From: Countryman, Ryan
Sent: Friday, February 05, 2016 5:04 PM
To: Gary Huff (GHuff@karrtuttle.com) (GHuff@karrtuttle.com)
Subject: Point Wells Parking
Attachments: Point Wells PRELIMINARY clarifications parking comments Feb 5 2016 version.pdf

SUPPLEMENTAL PROJECT REVIEW COMPLETION LETTER: REGARDING PARKING

PFN: 11 101457 LU / ____ (Other permits)

Figure 1 – Portions of Sheet A-053 with Highlights Added

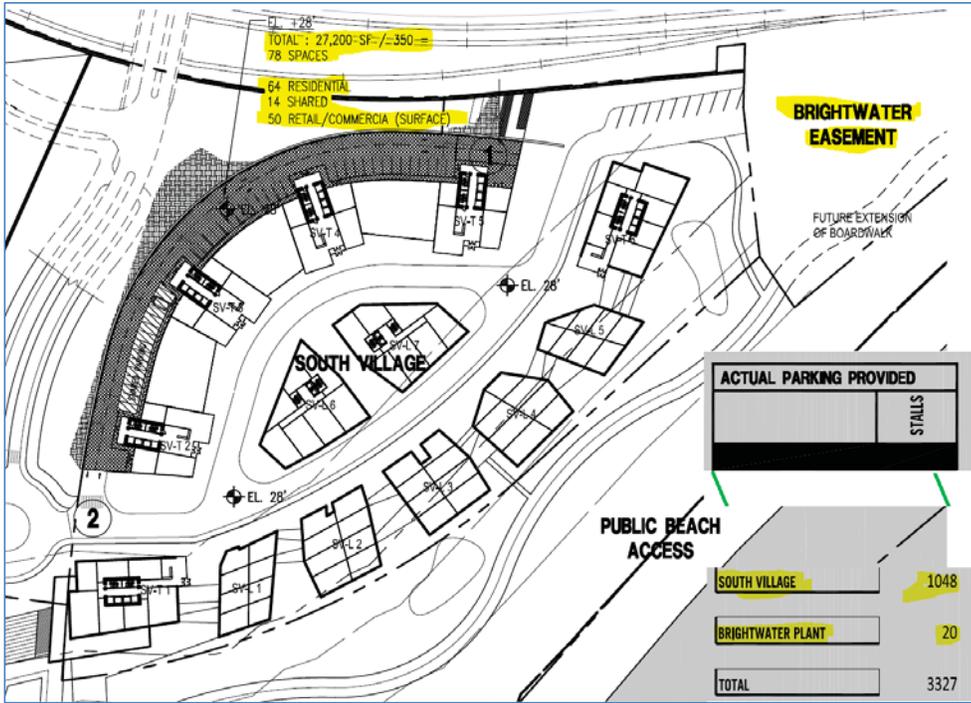
South Village Parking Details: Our understanding of the Urban Center submittal is that the figure of 1,048 stalls on Sheet A-053 uses an assumption of one parking stall for every 350 square feet of parking area, rather than an actual count based on the submittal drawings. This ratio assumes a very efficient design to the parking areas. Our professional judgment and the submittal drawings themselves suggest that the unusual geometries¹² of the site would make achieving this degree of parking efficiency infeasible. In other words, we do not see how it is possible to fit 1,048 parking stalls in the South Village.

Among other things, Sheet A-053 shows:

1. The surface parking for the South Village,
2. How drawing assumes one stall per 350 square feet of parking area,
3. The location of an adjacent Brightwater facility,
4. 20 parking stalls assigned to Brightwater, and
5. Purports to demonstrate 78 surface parking stalls in this area.

Sheet A-103 has a less cluttered illustration of the same area. Figure 2, next page, adds numbers to the parking stalls to create an actual count by purpose to the stalls shown. This count sums up to 53 stalls (15 shared, 28 for an unidentified purpose (presumably shared parking for the restaurants and retail), and 10 for Brightwater). These numbers conflict with the claims on sheet A-053 (Figure 1) that there are 78 surface parking stalls in the South Village and that the table listing parking counts represents the “Actual Parking Provided.”

Figure 3 – Layout of Parking Garage Level 1 for South Village from Sheet A-054

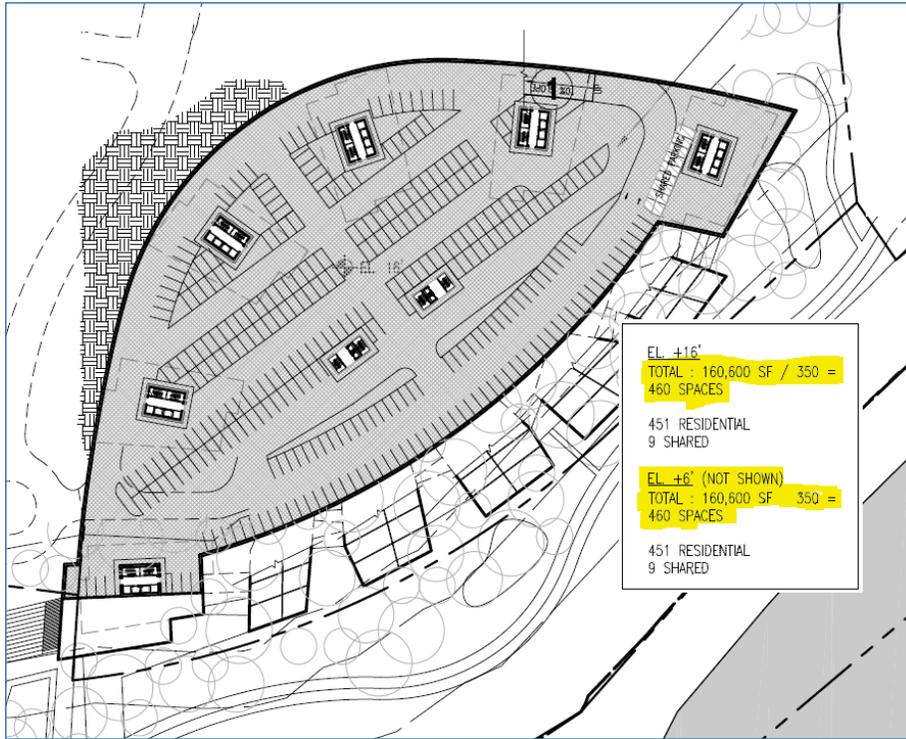
The challenge of reconciling the parking in South Village garage is similar to the issues with surface parking. The table titled “Actual Parking Provided” on sheet A-053 uses numbers that are really parking *estimates*. These estimates significantly overstate what the application shows for parking. Sheet A-054 shows the layout of below grade parking. It estimates that the garage would contain 460 spaces per floor based on dividing the total area by an assumption of one stall per every 350 square feet. However, by our count, there are around 327 spaces shown, but this count is in need of clarification because some of the stalls shown are ambiguous as to whether they would meet dimensional requirements (see Figure 4, next page).

Figure 5 – Urban Plaza Cross-Section from Sheet A-310

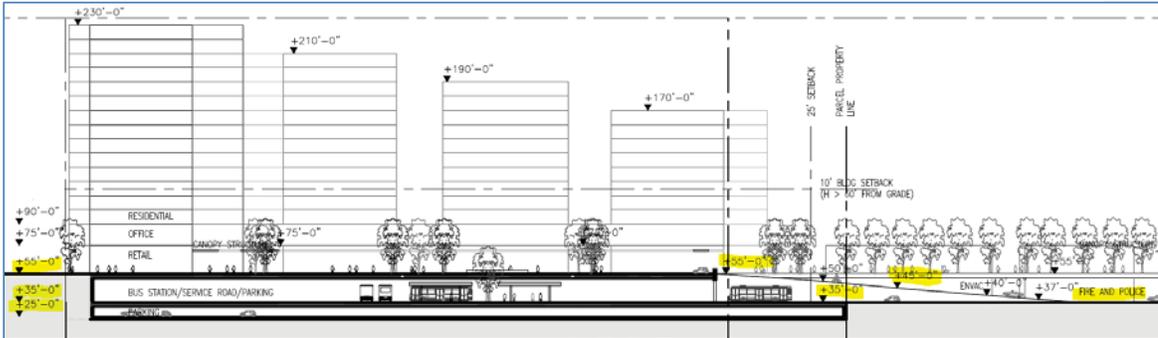
Urban Plaza Parking Details: The submittal drawings are confusing with respect to parking for the Urban Plaza. A cross-section on Sheet A-310 (see Figure 5, next page) shows parking on two levels of garage (at 25' and 35' in elevation) and potentially additional parking at the surface level (55' in elevation), yet there does not appear to be any parking at the surface. A summary of parking for the Urban Plaza appears on Sheet A-053. This summary does not match Sheet A-310. The summary sheet A-053 indicates that there is parking at 25', 35', and 45' (see Figure 6, next page). Based on the circulation plan on Sheet A-055 (see Figure 7, next page) we assume that the 45' figure on sheet A-053 actually refers to the 55' elevation. This assumption is consistent with Sheet A-310 because there are ramps at 45' that cannot possibly load into an additional level at this elevation. This assumption is also consistent with what is shown on Sheet A-310 where the ramps appear on the cross-section.

Figure 6 – Urban Plaza Excerpt from Sheet A-053

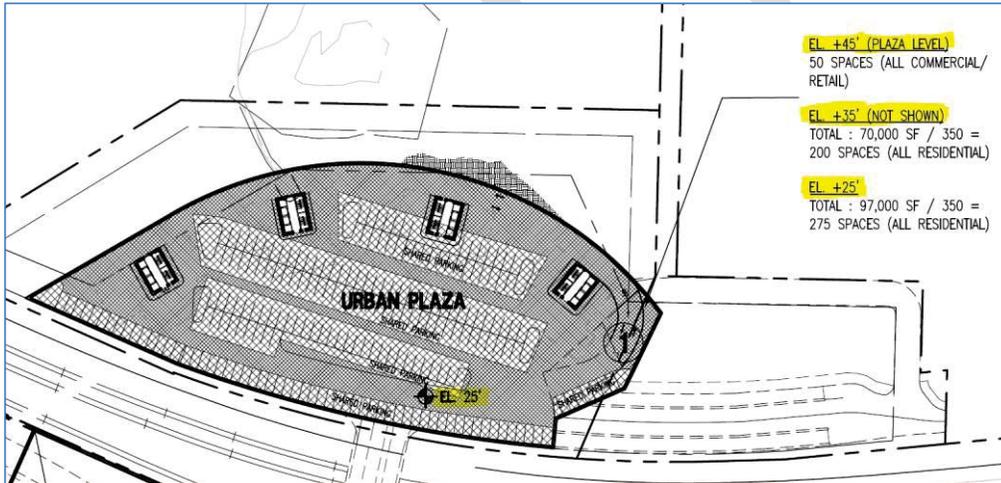
At the 55' elevation, Sheet A-053 states that there are 50 stalls for commercial (office)/retail uses (Figure 6). Yet, the detail on Sheet A-100 shows only circulation drop off at this level (see Figure 8 on page 13). There is no parking at the 55' level for the office or retail uses.

At the 35' elevation, Sheet A-100 shows a parking layout with 112 stalls (by Snohomish County's count) (see Figure 9 on page 14). This is different from the summary information on Sheet A-053 (Figure 6) which says that there are 200 residential spaces at this level. Because of the geometry of the site and the bus drop-off area, it is probably impossible to redesign the parking at this level to provide 200 stalls. Similarly, at the 25' parking elevation there appears to be just 201 stalls whereas Sheet A-053 says that there are 275 stalls.

Figure 10 – Central Village Surface Parking from Sheet A-053

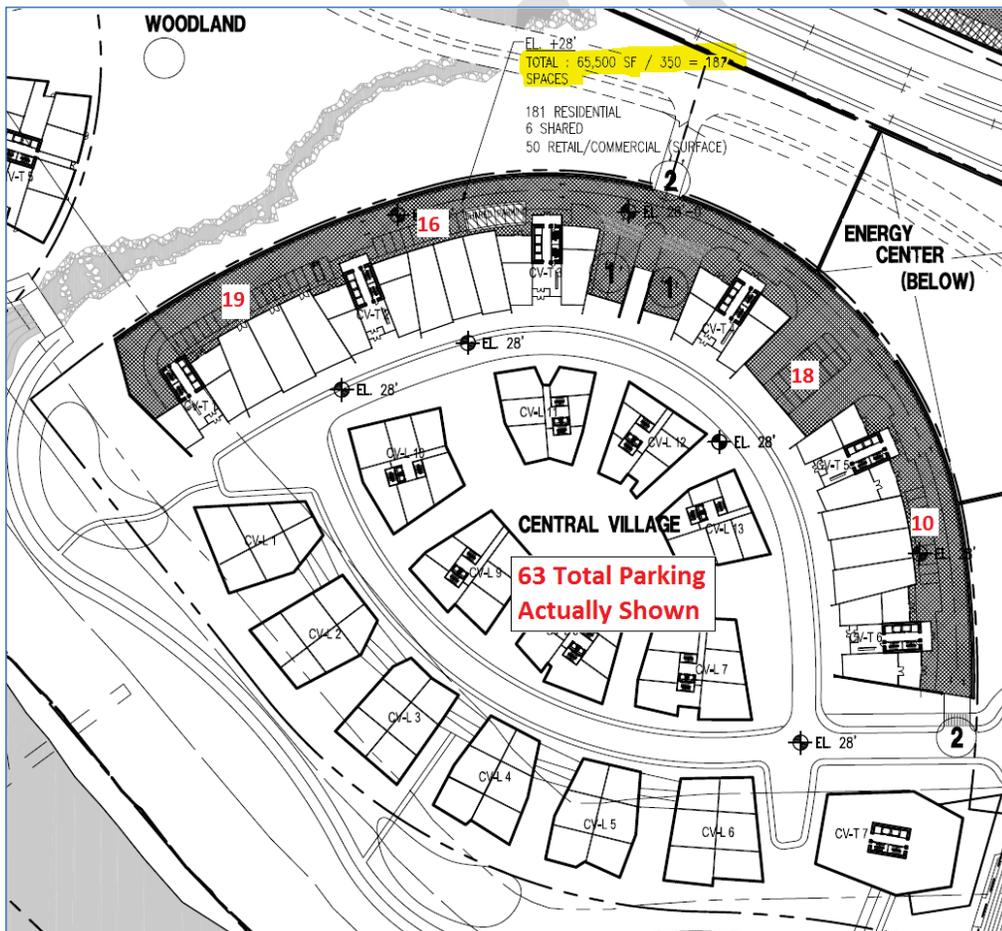
Central Village Parking Details: The submittal drawings state that there are 962 stalls provided in the Central Village (Sheet A-053), yet the drawings themselves show only 775 stalls in total. Figure 10, next page, shows that there are only 63 surface stalls where the drawings estimate that there are 187. In the parking garage, Figure 11 on the next page demonstrates that there are 712 stalls in the garage yet Sheet A-054 says that there are 725 spaces.

Figure 12 – Landscaping Near Brightwater Parking Area (Adapted from Sheet L-101)

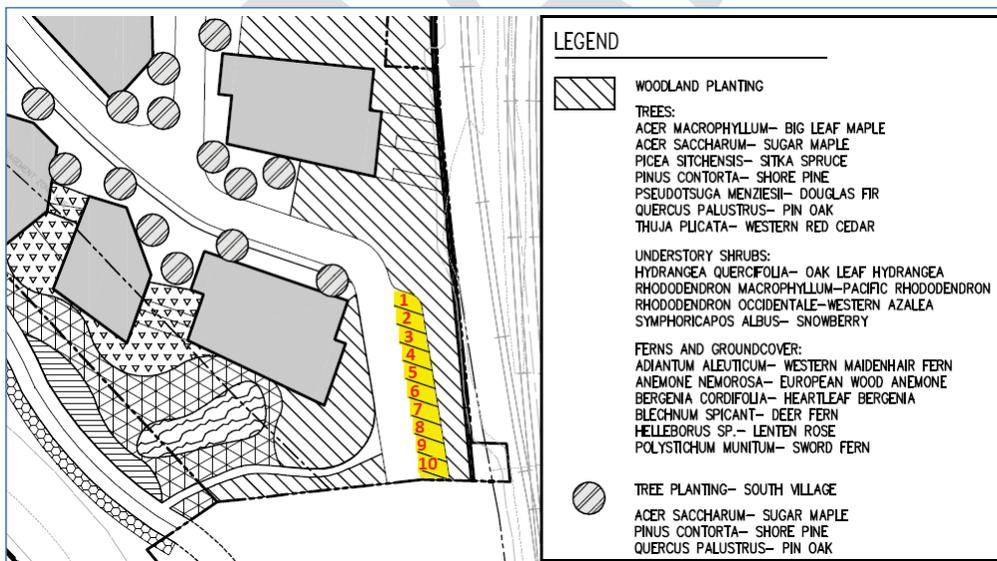
Subsection (3) says that, “Parking lots must be landscaped pursuant to SCC 30.25.022.” Since nearly all of the parking is below buildings, only parking shown for Brightwater would be subject to this requirement. Per SCC 30.25.022 this parking lot area may need to include a landscaping island; however, other comments relating to parking area may require a redesign of this parking. These other comments involve:

1. Fire access turnarounds or circulation (Add reference after these comments are written.)
2. The number of stalls provided for Brightwater (Sheet A-053 says that the “Actual Parking Provided” is 20 stalls, but there are only 10 stalls shown).

Figure 14 – Example of Share Parking from Sheet A-053.

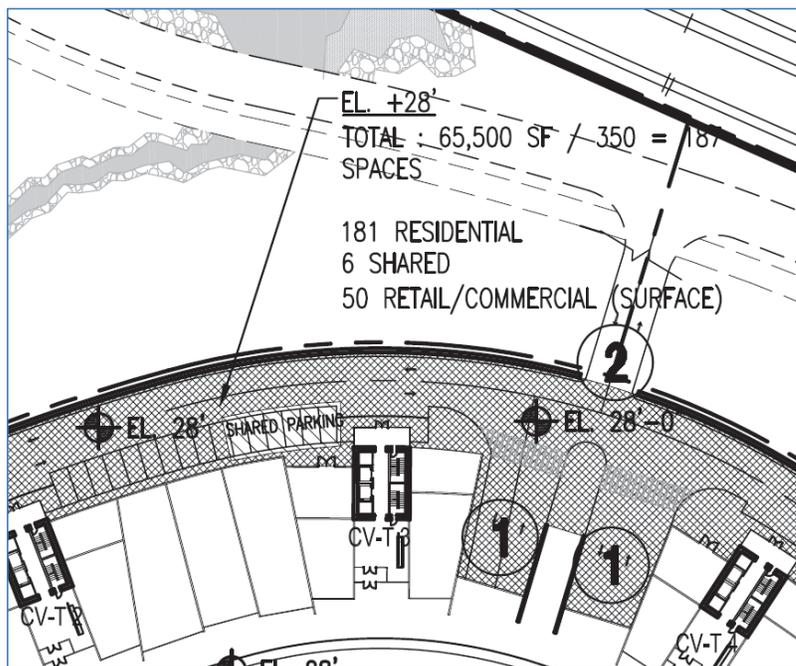
“shared parking” areas as illustrated in Figure 14, below. Snohomish County interprets these as intended to be synonymous with parking for joint uses as allowed for by SCC 30.26.050, but the application does not currently include sufficient information to joint or shared parking for mixed uses.

The planning department may authorize joint use of parking facilities for as suggested in Figure 14, above, but the applicant must request this and provide information to demonstrate that the project meets the conditions for joint use. The applicant will need to provide this information or PDS cannot recommend approval of a site plan with shared or joint use parking.

Figure 15 – Loading Areas in Urban Plaza Adapted from Sheet A-100

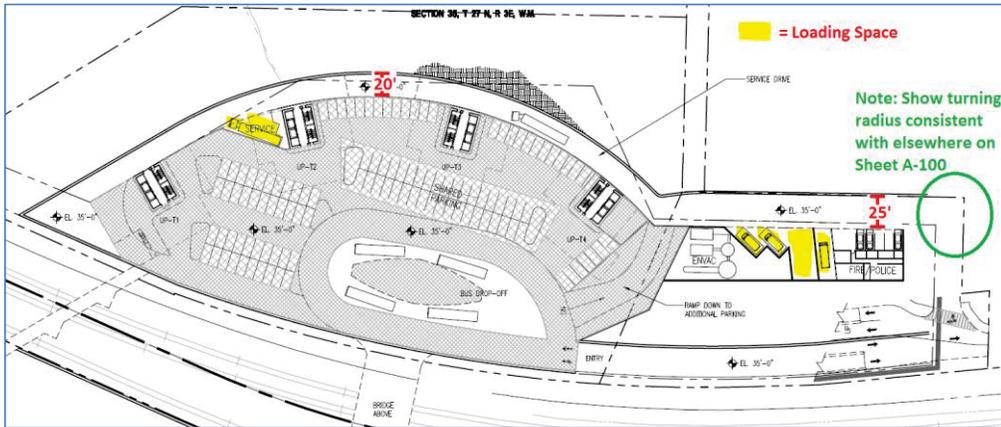
The only phase that shows loading spaces is the Urban Plaza (see Figure 15, next page). Per SCC 30.26.060(3), the number of spaces shall be one “for every 20,000 square feet, or fraction thereof, of gross building area”.

The application proposes 26,300 square feet of supermarket in the Urban Plaza. Two loading spaces are required for the market and two are proposed. It is not clear, however, whether adequate space for standing, loading, and unloading has been provided (SCC 30.26.060(2)) or whether it is possible that “no part of a truck or van using the loading space will project into the public¹⁶ right-of-way” (SCC 30.26.060(4)).

The application also proposes ENVAC (garbage collection/compaction) and fire/police areas in the Urban Plaza. Loading areas for these are proposed, consistent with SCC 30.26.060(1)(m) and the proposed spaces appear to meet the basic dimensional requirements of county code. However, we cannot assume standard dimensional loading to be adequate for these users. Snohomish County recommends that the applicant request letters from the proposed service providers stating that the proposed loading areas are adequate. **[Need to add reference to authority for this requirement.]**

Finally, we note that the proposal for the service drive includes 25' width at the ENVAC and fire/police area but it would then constrict to just 20' wide in the area of the service loading for the market. The portion with 25' is consistent with the perpendicular car parking at the police/fire area (see related discussion of former SCC 30.26.065 Parking Lot Development Standards below). However, at the service loading for the market, the application will need to show how “continuous, unrestricted vehicular movement” will be provided if trucks accessing the loading area need to stop, block traffic, and back up to access the loading spaces (*former* SCC 30.26.065(2)). The same concern exists, to a lesser extent, at the loading for ENVAC and fire/police.

Figure 17 – Illustration of Parking Type and Drive Aisle Width adapted from Sheet A-100.

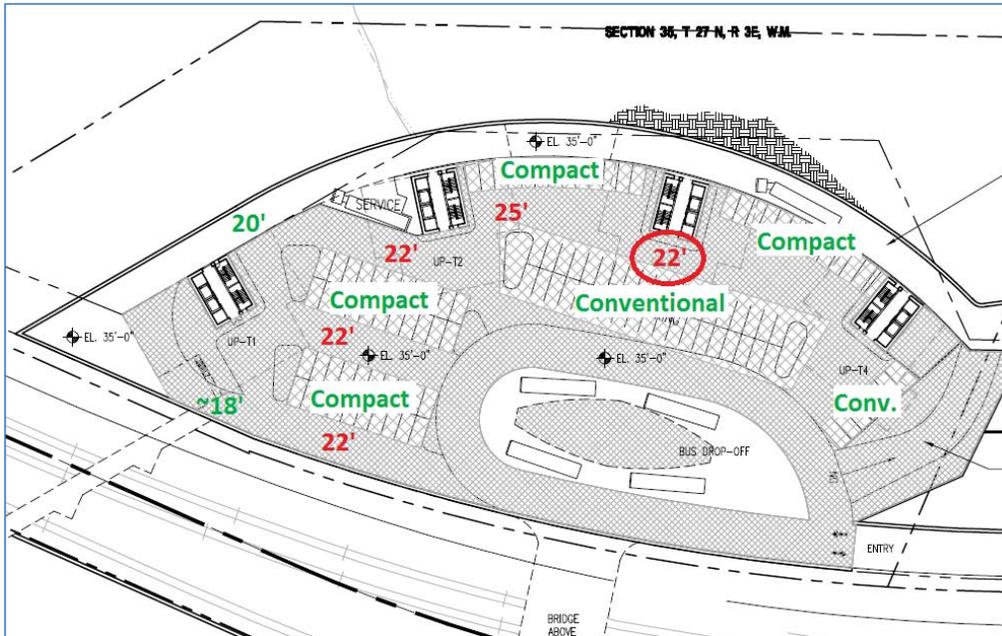
SCC 30.26.065 describes many of the parking lot standards within its 19 subsections. In the context of reviewing the Urban Center submittal, the most important issue from this section is an error on Sheet A-053. This error states that drive aisles in parking lots can be 22' clear for compact parking stalls. Per Tables 30.26.065(14) and (16), drive aisles can be 22' only when there is

Twenty five-foot drive aisles are required next to conventional stalls when there is two-way traffic. All of the parking shown on the submittal drawings is perpendicular parking, i.e. the angles are all 90 degrees. Many of the drive aisles shown to be just 22'; this implies that they will have one-way traffic and compact parking stalls.

Up to 40% of the stalls may be compact and the compact stalls must be individually marked on the site plan (SCC 30.26.065(10)). While the compact stalls are not marked, we can deduce that some areas are for compact and others for conventional parking based on the dimensions of the parking areas. Overall, each parking floor must have at least 60% of the stalls as conventional stalls and conventional stalls must have 25' drive aisles. It is therefore not possible to have as many 22' drive aisles or compact stalls as shown (see Figure 17, below).

Figure 18 – Examples of Additional Parking Problems Adapted from Sheet A-054

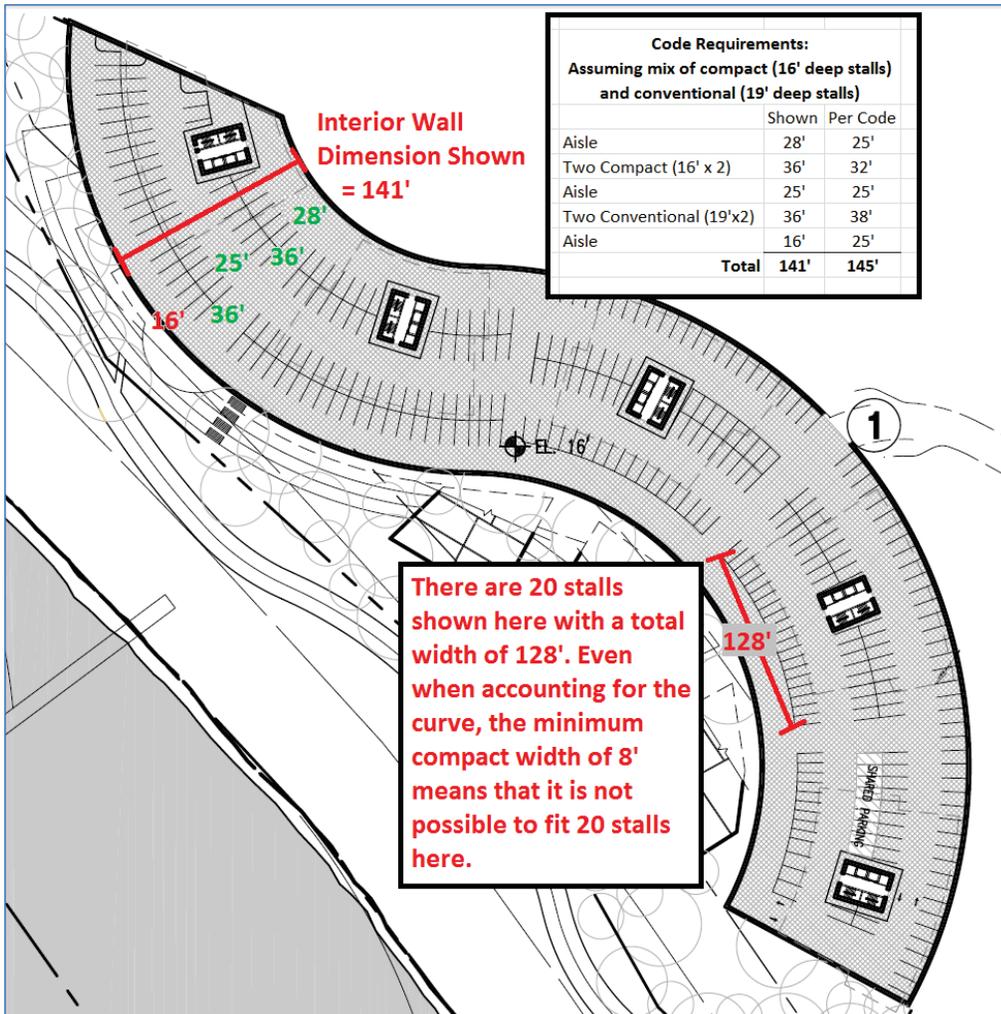
Additional problems with parking design occur throughout the submittal drawings. The garage plan for the North Village (Sheet A-054) is especially problematic and shows some of the other types of errors. These include trying to fit parking areas and drive aisles into areas where they cannot meet code requirements and proposing stalls with less than the 8' minimum necessary for compact parking. See Figure 18, next page.

The parking design will need thorough secondary review following a resubmittal that addresses the problems identified above.
